SI M31 01 15  
Front Axle

This Service Information bulletin supersedes SI 31 01 15 **dated March 2015**.

**Front Axle Noise when Turning at Low Ambient Temperatures**

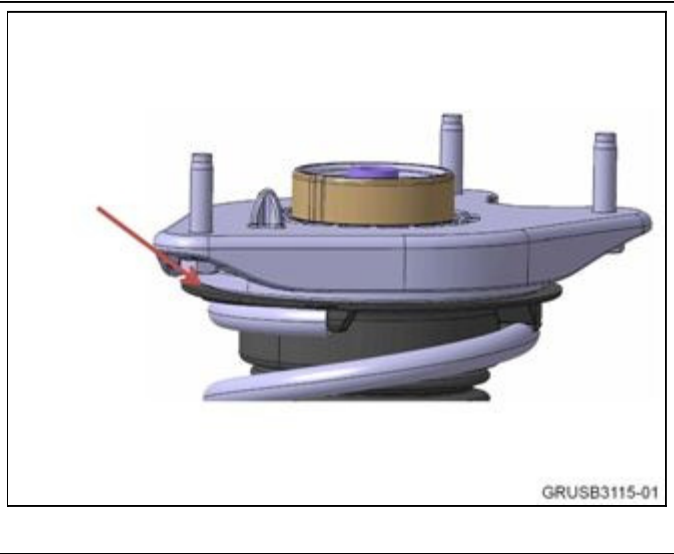
A groaning and/or squeaking noise from the front axle occurs when turning at low speeds or idle.

**NEW** The noise is most noticeable at low temperatures (approx. 32 degrees F), but not at higher temperatures and after driving.

<p>Lubricate the surface between the spring pad and spring strut support bearing. To do this, the support bearing must be removed. Refer to ISTA REP 3133001 "Replacing the spring strut support bearing at the front left or right".</p>
	<p>Clean dirt off surfaces of the spring pad and spring strut support bearing.</p>

Apply a thin coat of lubricating grease P/N 07 55 9 056 992 or P/N 83 23 0 301 796 to the entire surface of the spring pad and spring strut support bearing
